Subject: Byron Generating Station Units 1 and 2  
Independent Design Inspection  
NRC Inspection Report Nos. 50-454/83-32  
NRC Docket Nos. 50-454 and 50-455

June 19, 1984

BYRON IDI RESPONSES

FCR F-9079

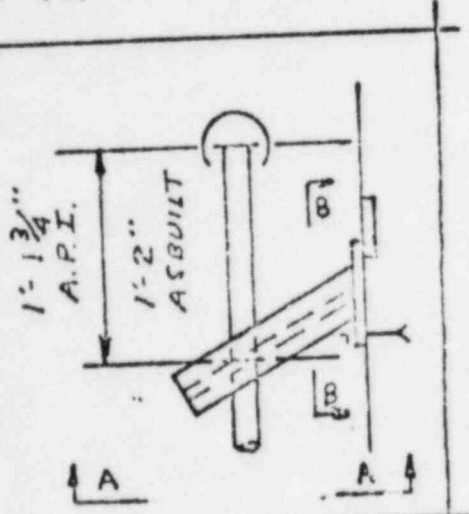
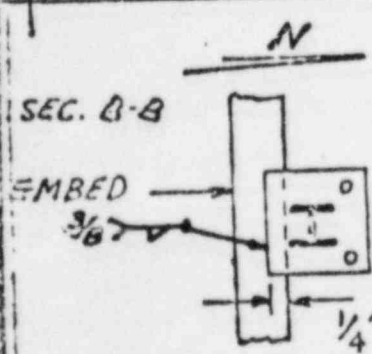
1. FCR F-9079
2. The backup calculation
3. Revision C to Support Drawing 1AF03009R"

Byron FCR F-9079 (dated 4-16-81) was written against Revision B of support drawing 1AF03009R to have a 1/4-inch overlap on its embedded plate. This FCR was picked up on Revision C of the drawing and issued on 12-23-81. Subsequently, this FCR was closed out on 1-9-82 as shown on Part D of the first page of the FCR.

ITEMS 4, 6 & 8 WERE CHANGED TO FIT ASBUILT PIPE.

- ④ 5/8" x 8 1/2" LONG T.F.L.
- ⑥ 5/8" x 8 3/4" LONG T.F.L.
- ⑧ 1'-2 1/4" LONG

FIGURE F4.1-1

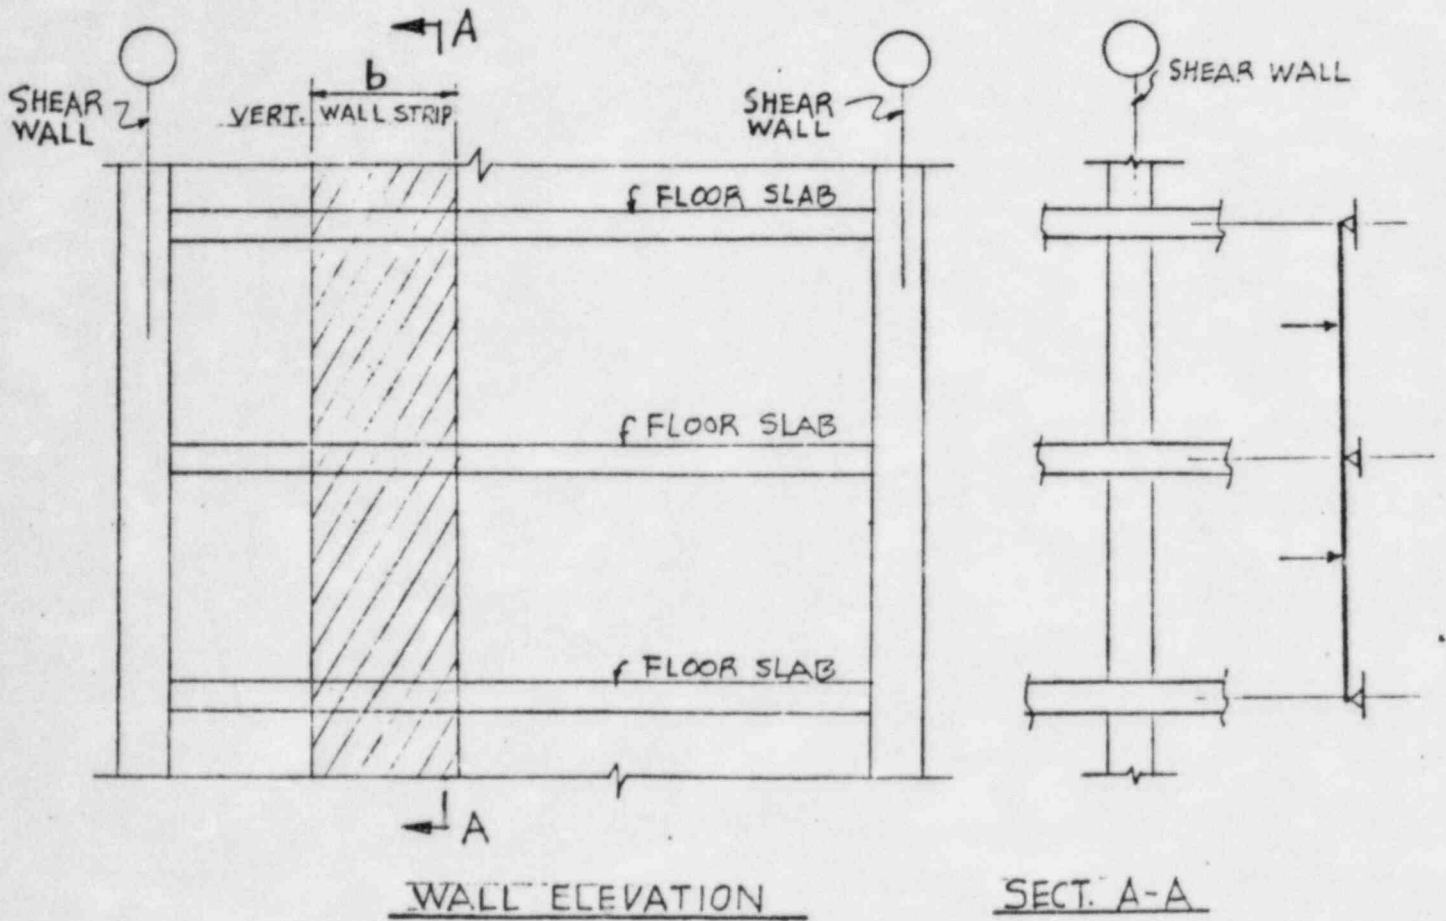
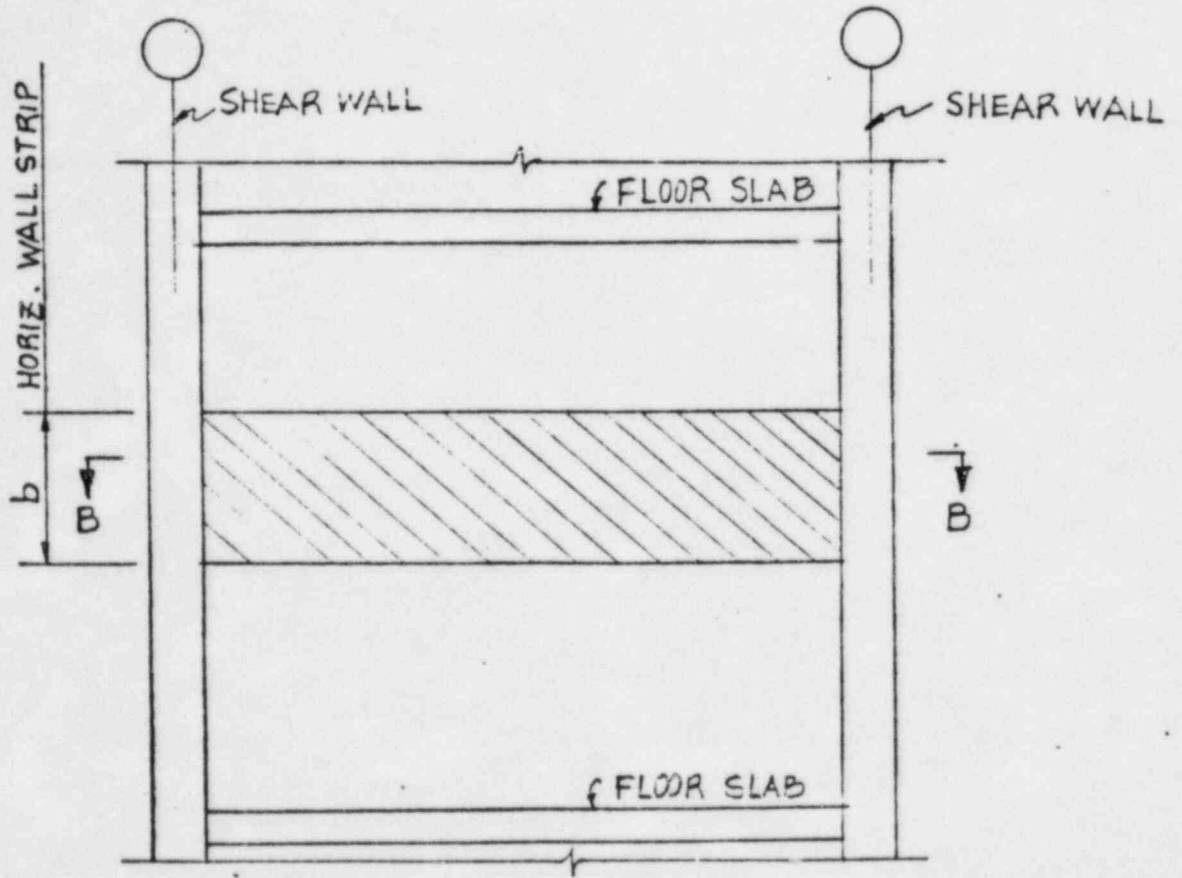
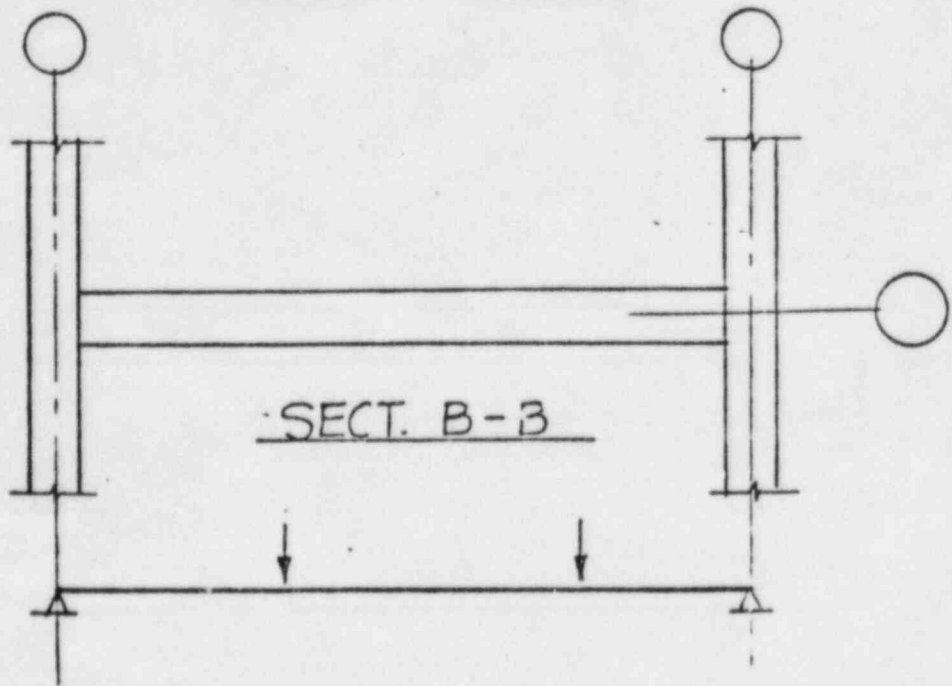
For a given wall loaded with a transverse wind load, describe how the transverse load at the center of a wall between two supporting orthogonal walls (shear walls) is carried out through the wall to the orthogonal walls which carry the shear force as in-plane shear in a normal shear wall concept. Describe how Sargent & Lundy determined the load capacity of the peripheral wall loaded transversely and converted these forces to stresses and then to reinforcing areas, if required. Describe how these same loads are addressed in the final load check. The use of diagrams to illustrate the details is recommended."

The transverse flexural steel area required for each wall strip was calculated using the flexural strength provisions of Chapter 10 of ACI 318-71. The transverse shear friction steel area required was calculated using the shear-friction provisions of Chapter 11 of ACI 318-71. Transverse loads are addressed in a similar manner in the final load check.

FIGURE U4.2-1\*

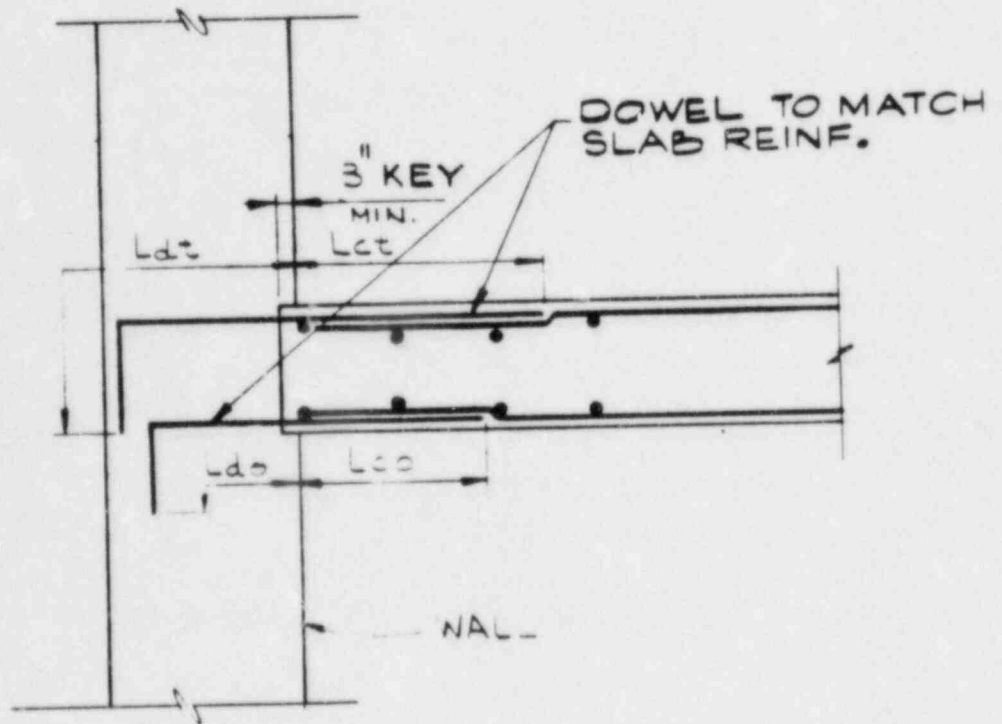
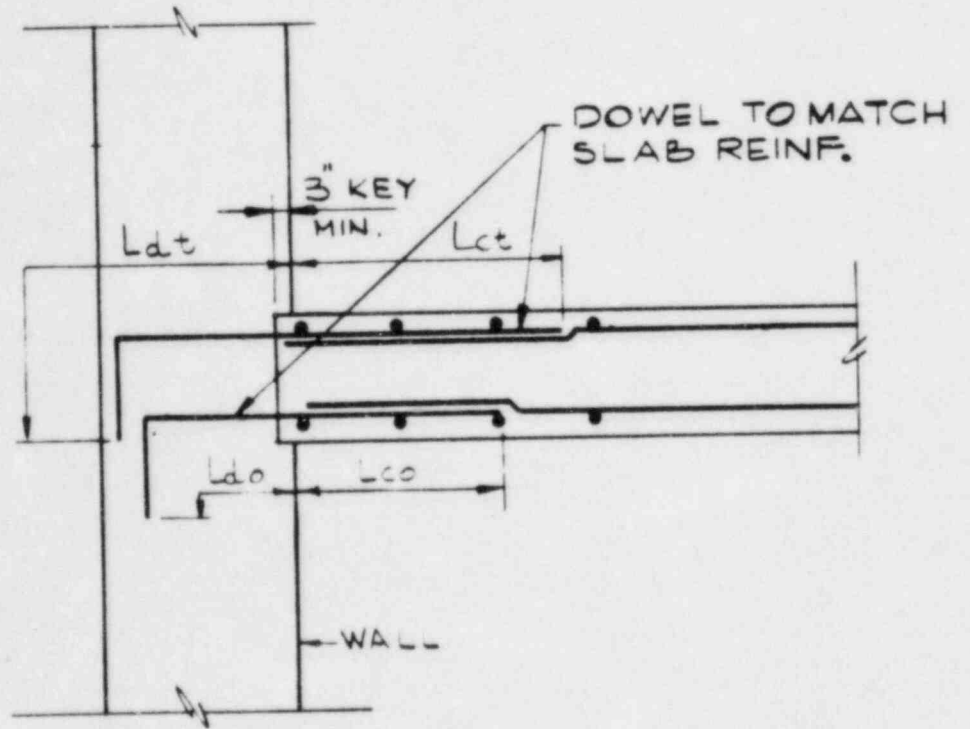
"The design procedure outlined in the response, if applied for all slab designs on the Byron project, would yield conservative steel areas (bottom steel) for midspan positive moments. You are requested to indicate whether this concept was used throughout the plant. Indicate if the procedure described in the original answer for supplying negative steel (top steel) at each slab boundary was used throughout the project and if so what portion of the maximum moment for a simply supported case was provided in negative moment capacity at the boundaries. Indicate, by providing detailed references to written documents, how these project-wide concepts (if used) were provided to individual designers in the way of instructions or procedures. If no project-wide concept was applied, indicate what technique was used in providing slab reinforcing based on varying boundary conditions."

As noted in our original response, negative moment steel equal to that at the continuous support was provided at the junction to the wall of slab 4AB53. This is a conservative design approach which was used for all slabs supported by walls. This typical detailing is shown as Slab Support Types 5 and 6 (see Figures U4.2-1 and U4.2-2) on Structural Drawing S-473 which was included in project Specification F/L 2722 and initially released to the appropriate contractors on August 7, 1974.

These standard details are specified for construction at all slab-to-wall junctions and, because they are standard details, no other reinforcing arrangements could have been used. Thus, their use is a project-wide concept and did not depend on the judgment of the individual designer involved.
